N10944_02

Information Only Service Note

N1094A DCA-M Sampling Oscilloscope

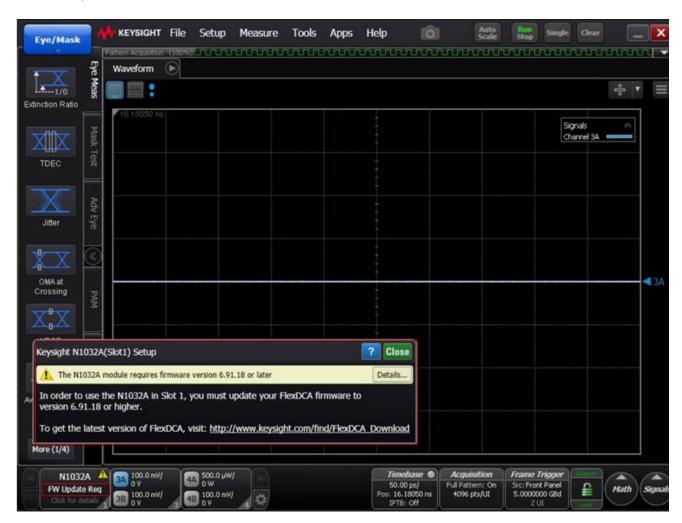
With the instrument connected to FlexDCA, if a message like the one below is displayed, FlexDCA must be updated to the indicated version (or later):

To update FlexDCA software, download from www.keysight.com/find/flexdca_download and install. While only the indicated version is required, updating to the latest version is recommended.
